World Forum for Harmonization of Vehicle Regulations

Working Party on General Safety Provisions

107th session

Report of the Working Party on General Safety Provisions on its 107th session

Figure 1-1, amend to read:

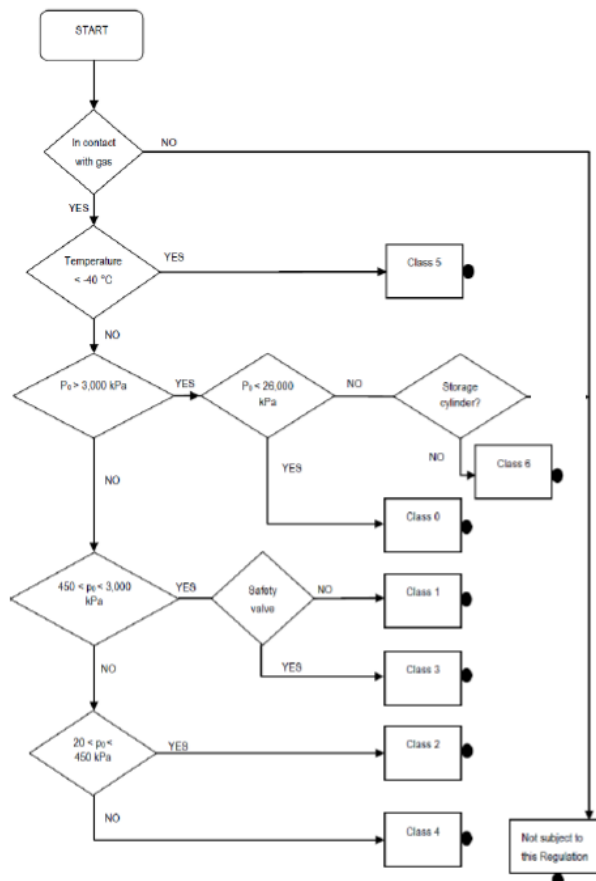
**Draft amendments to Regulation No. 110
(para. 22) (based on ECE/TRANS/WP.29/GRSG/2014/27)**
